13 May 2024

Mareeba Shire Council
65 Rankin Street
PO Box 154
Mareeba QLD 4880

**Response to Pre-Request for Information
2-4 Quill Street, Mareeba (OPW/21/0006)**

PROJECT REF	CONMAT PTY LTD		
	QUILL STREET LAND DEVELOPMENT		
DRAWING REF	DRIVEWAY		
	LONGITUDINAL SECTION AND DETAIL		
DRAWING NO	160-001-C106	SIZE	A3
REVISION			B

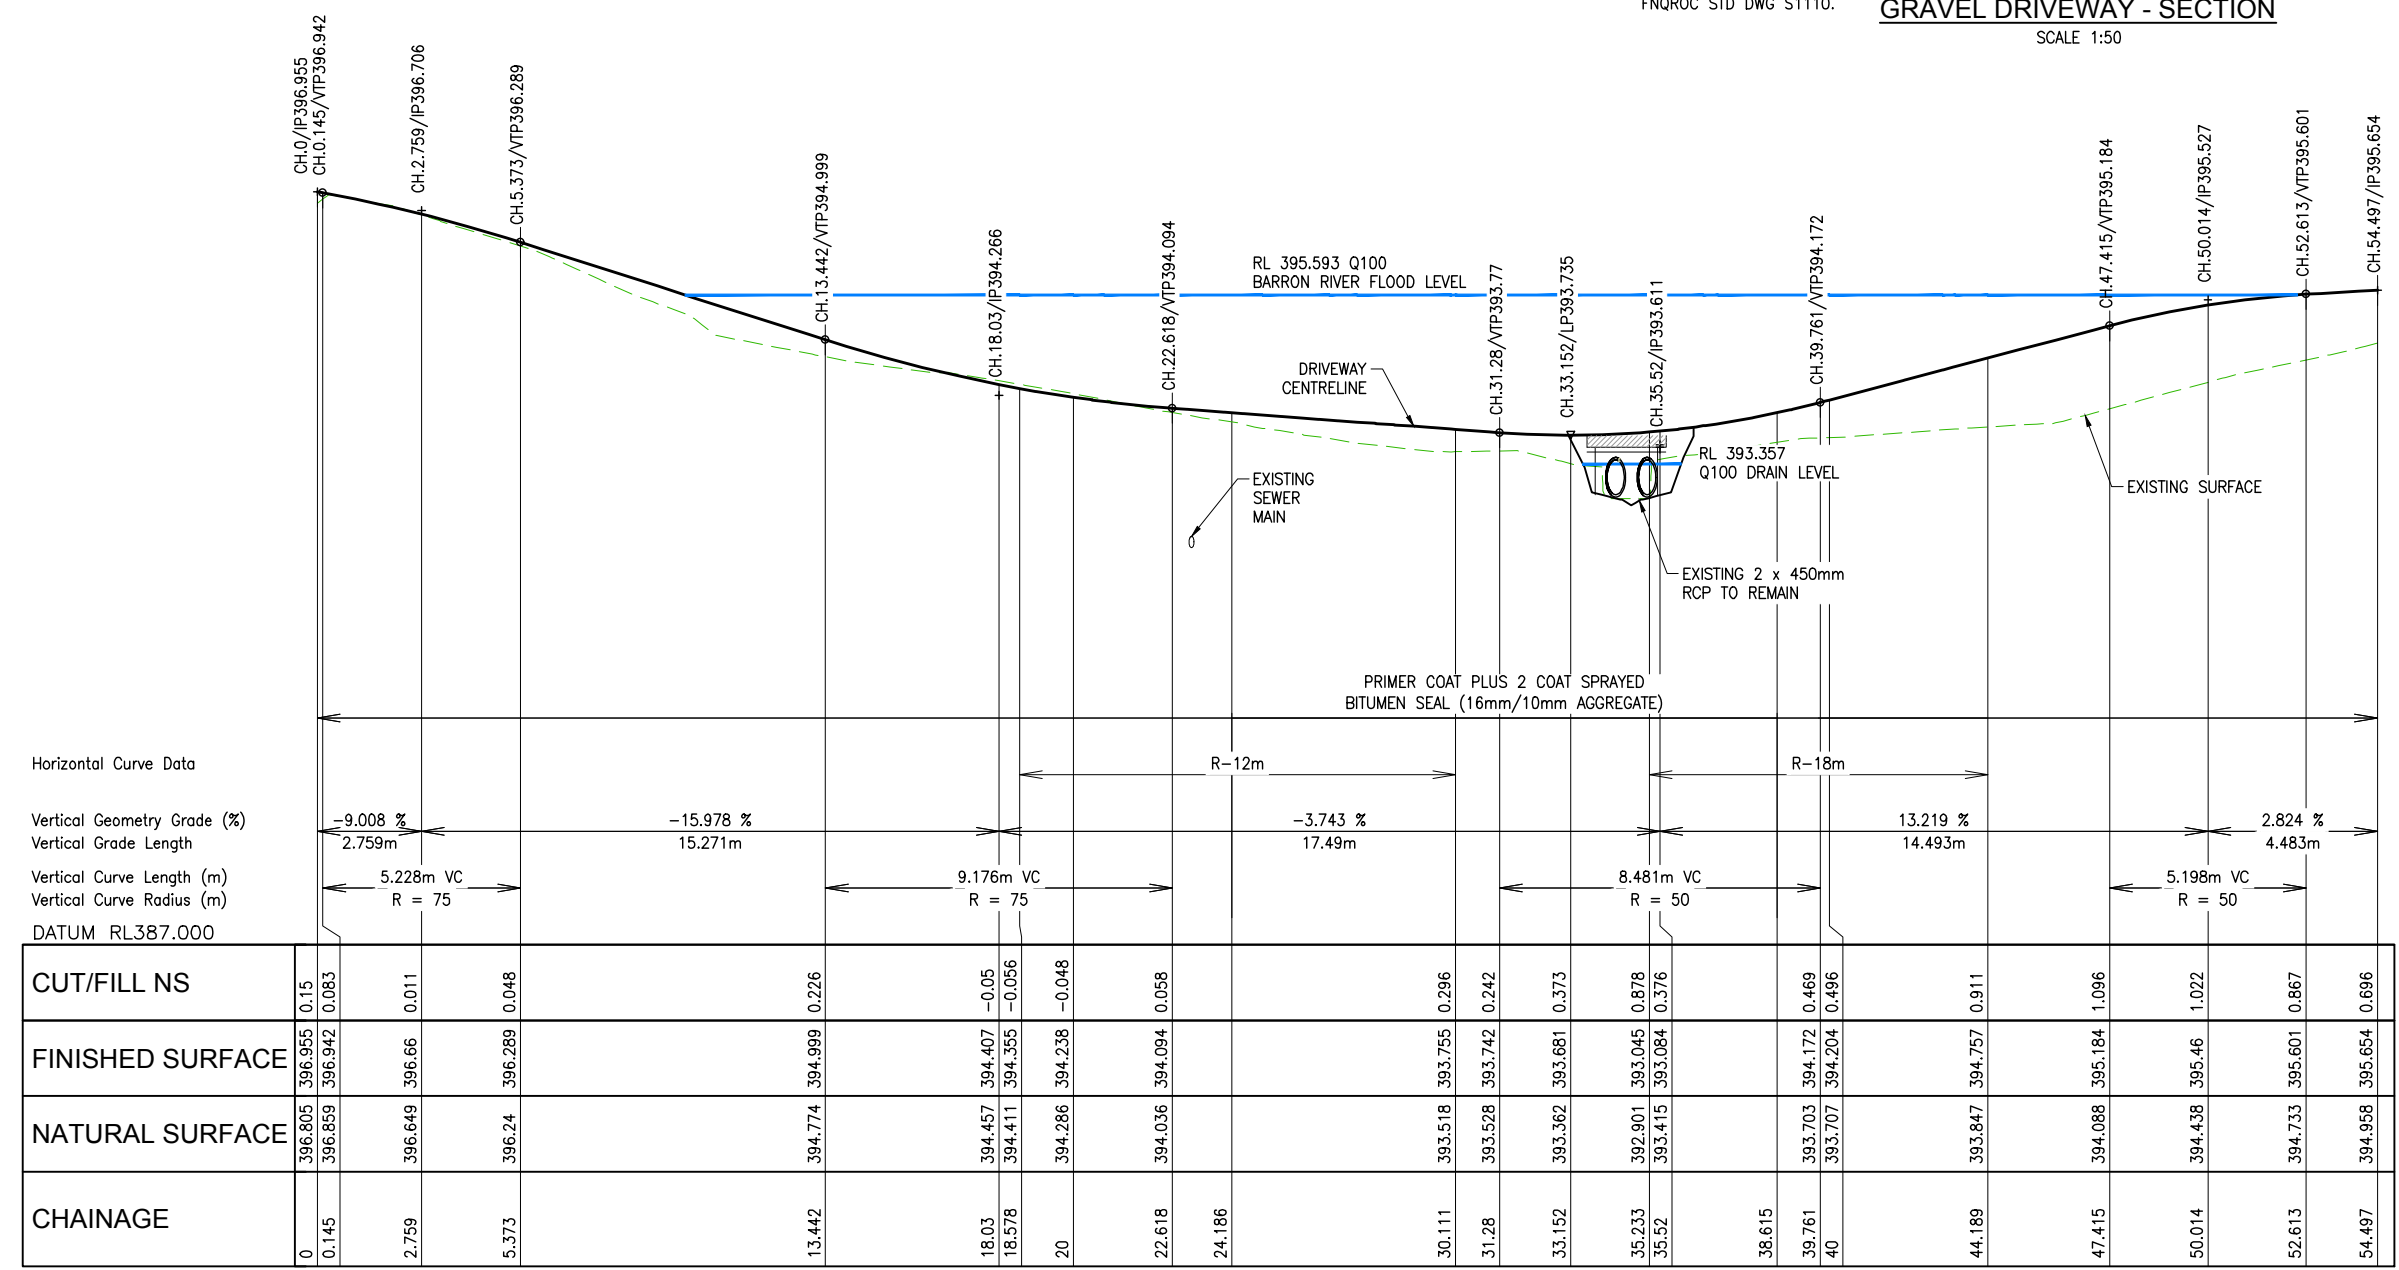
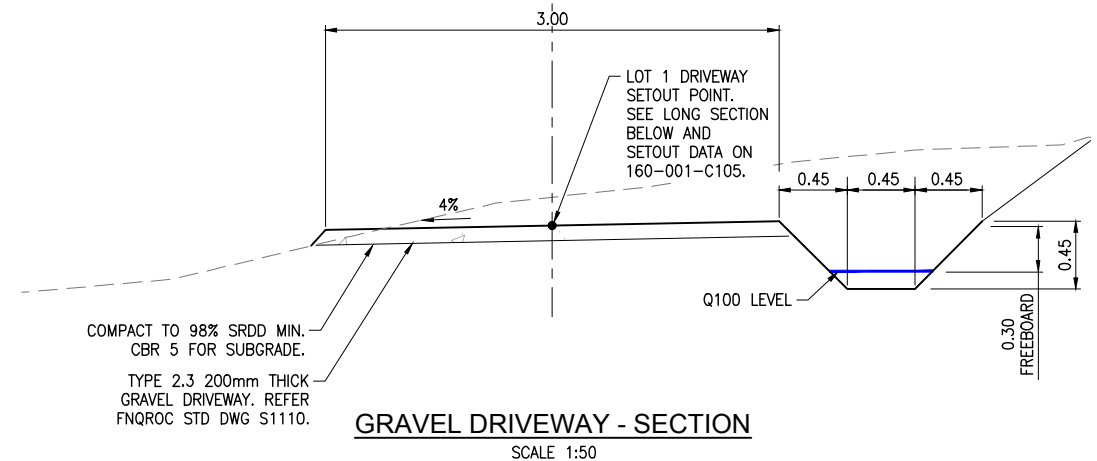
8. Confirm the data source for the 1% AEP flood level shown on the cross section on Drawing C106. Amend the drawings to include the level value (RL) determined for the 1%AEP (Q100) water surface on the drawing C106.

If the flood level shown does not represent Barron River flooding, provide advice on the immunity of the driveway from a Barron River flood event. (That is; what frequency/occurrence event overtops the driveway).

Advice Note; The inundation extent shown on SK07 in Appendix C of the design report appears to differ from water level shown on Drawing C106. The applicant is requested to clarify the different flood levels/extents.

The Q100 level for the backflow of the Barron River of RL395.593 was supplied by council. The RL achieved for the stream flow Q100 RL 393.357 is based on our calculations of contributing catchments and a flow height of 597mm above the invert level.

PROJECT REF		CONMAT PTY LTD	
DRAWING REF		QUILL STREET LAND DEVELOPMENT	
DRAWING NO		ROCK LINED DRAIN	
SIZE		LONGITUDINAL SECTION AND DETAIL (SHEET 1 OF 2)	
REVISION		160-001-C107	
DATE		A3	
RPEQ		A

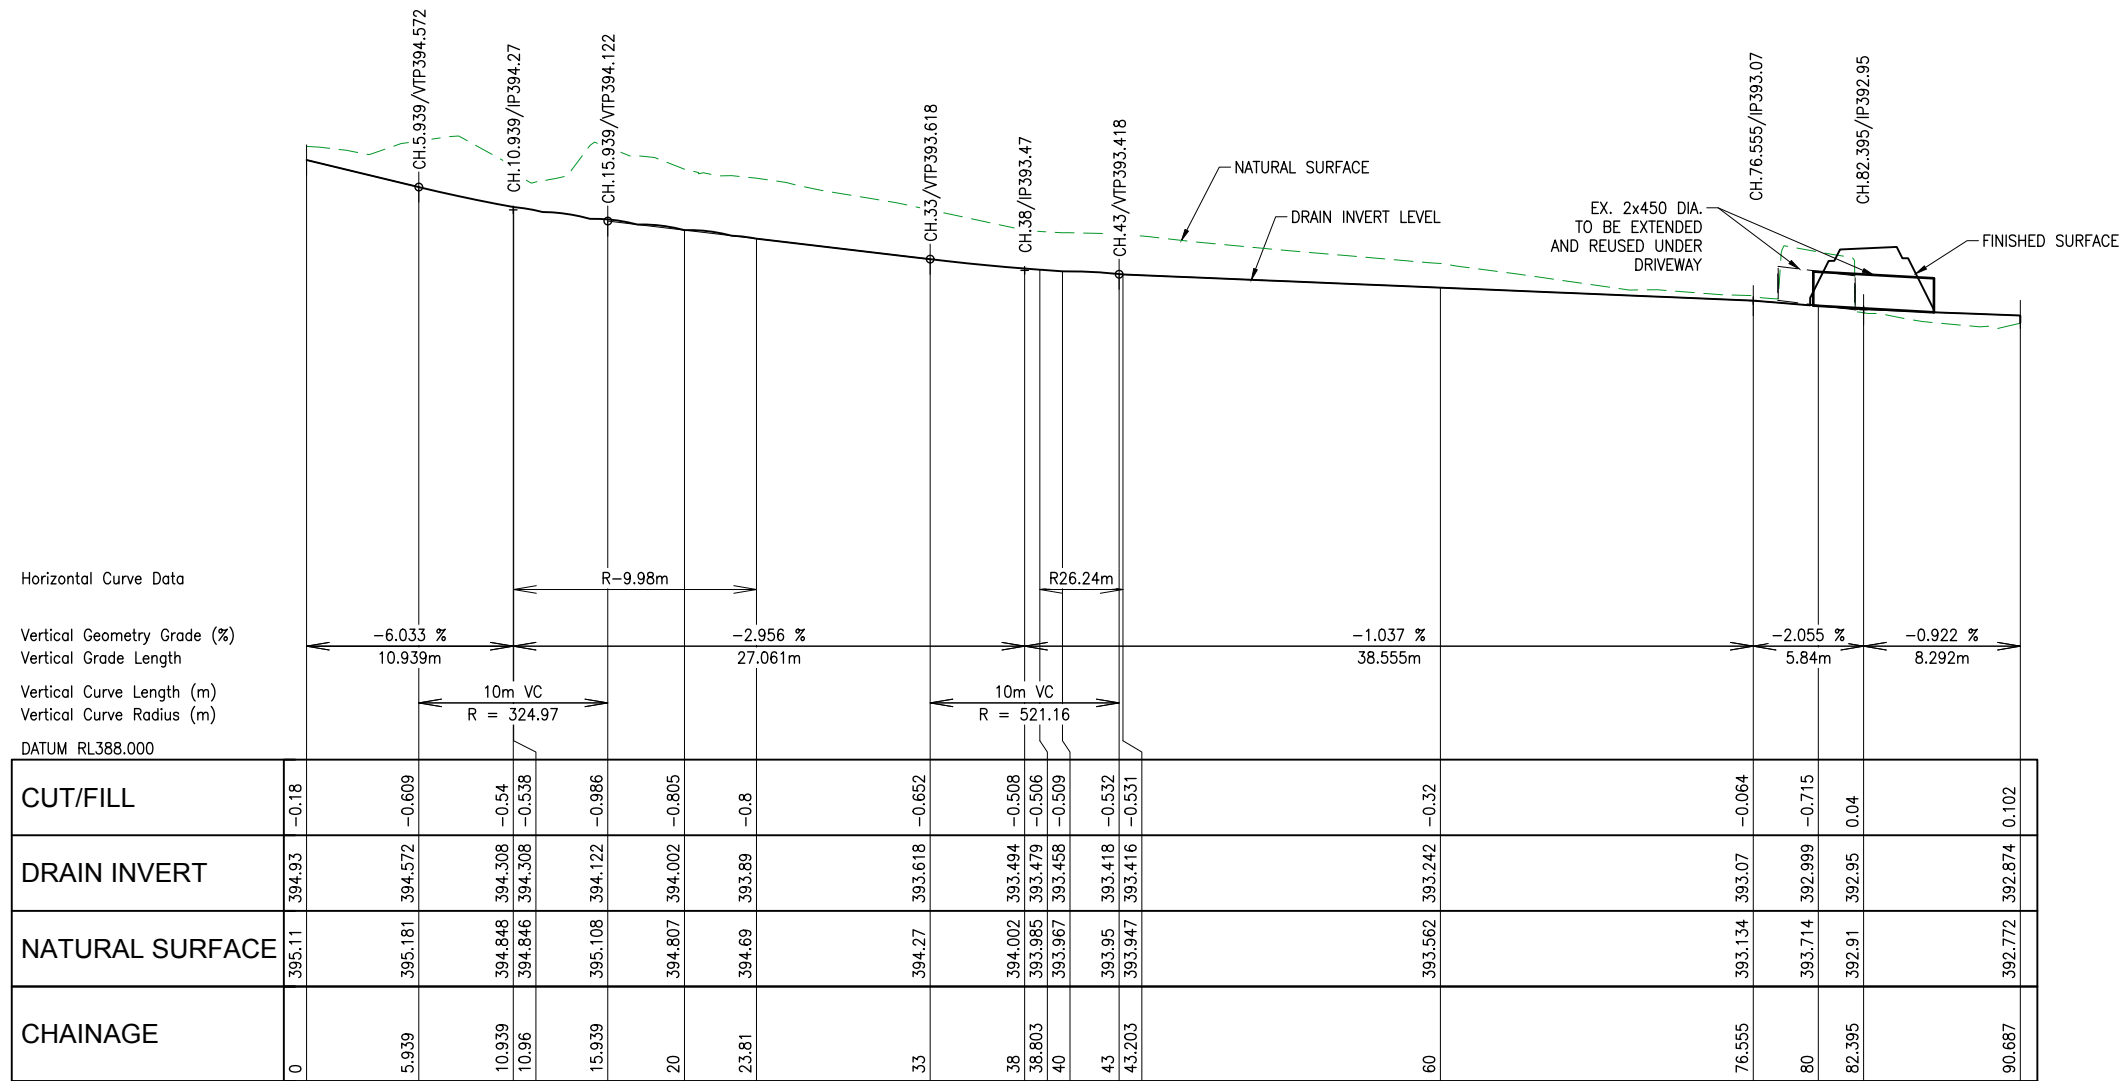
7. The Applicant is requested to update the signed Revision A drawings to include the details and dimensions of the proposed Rock Lined Drain.

Advice Note: The unsigned drawing set includes the drain detail, however, the detail is not included on the signed drawing set.

Drawing 160-001-C07 - Rev B has been amended to include the Rock Lined Drain detail.

PROJECT REF:	CONMAT PTY LTD	
	QUILL STREET LAND DEVELOPMENT	
DRAWING REF:	SEWER RETICULATION PLAN	
DRAWING NO:	160-001-C109	SIZE: A3
		REVISION: B

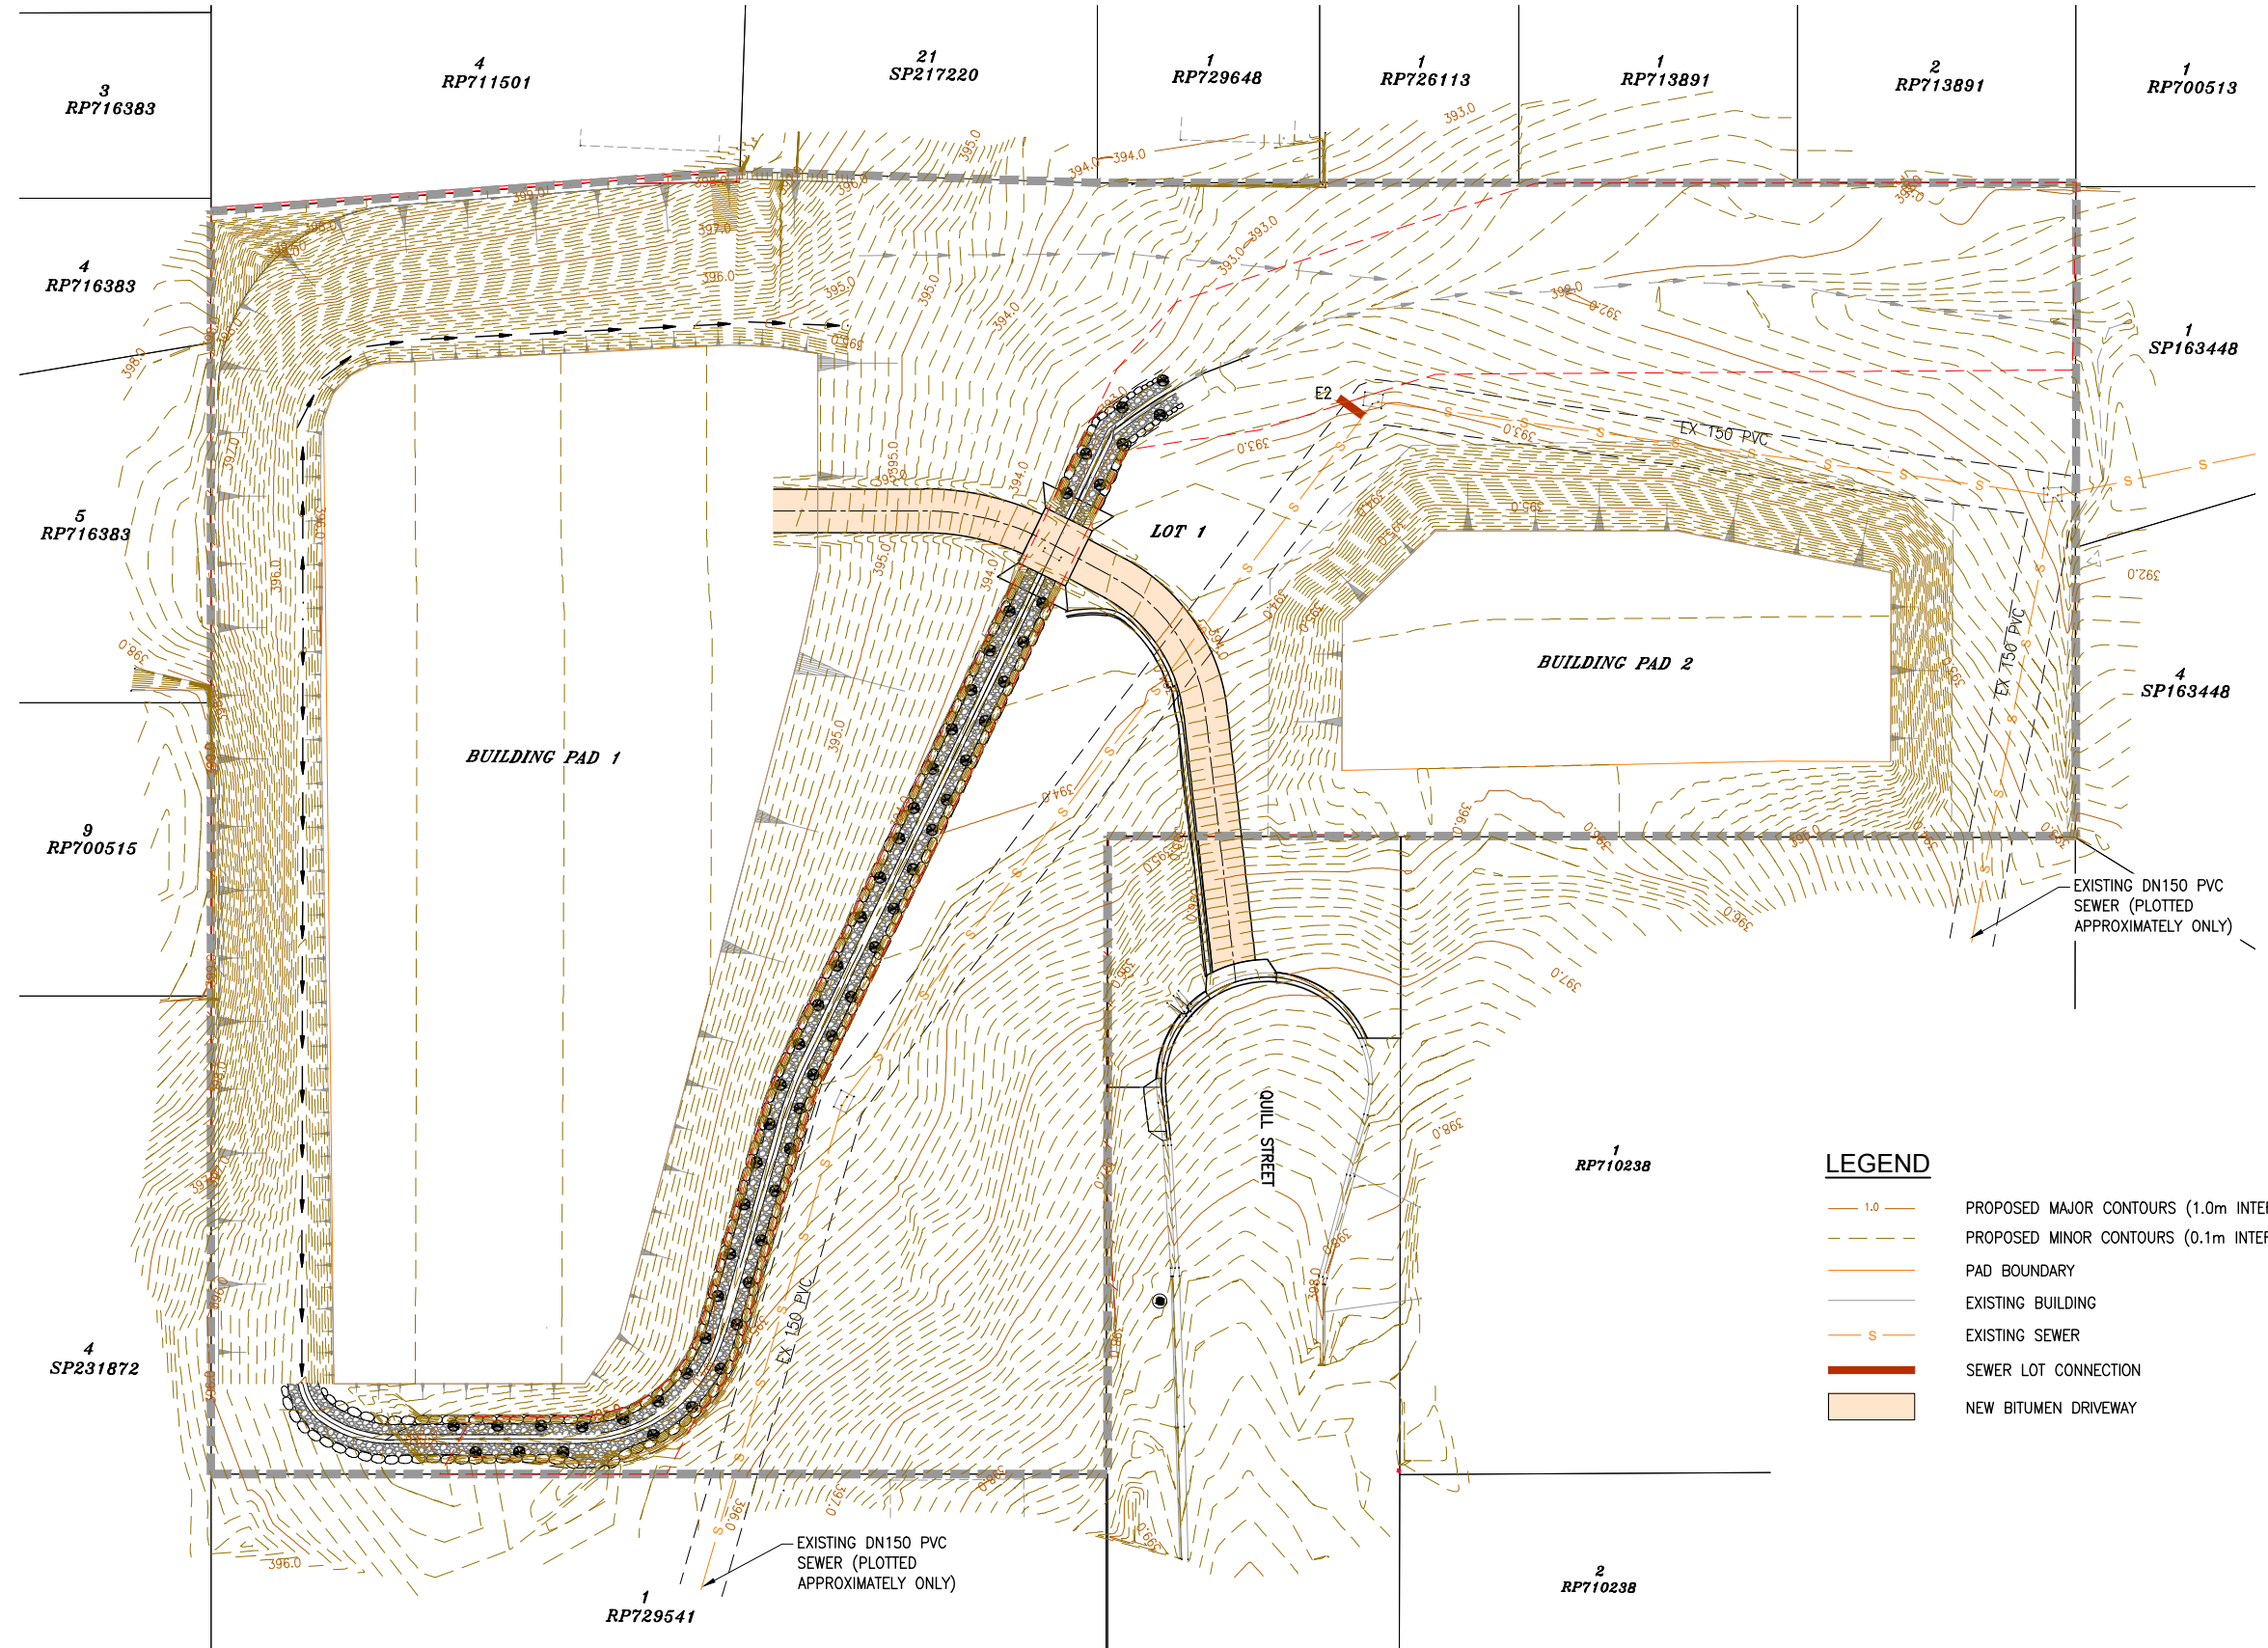
19. The applicant is to detail the proposed method of “cutting in” the new property connection branch to the existing sewer. This must be specified clearly so that the method can be considered by Council’s sewerage officers and appropriate conditions applied to the work scope.

An E2 connection is indicated on Sewer plan C109. The depth at this point is 1.15m below surface level. Both pads can achieve control at this level.
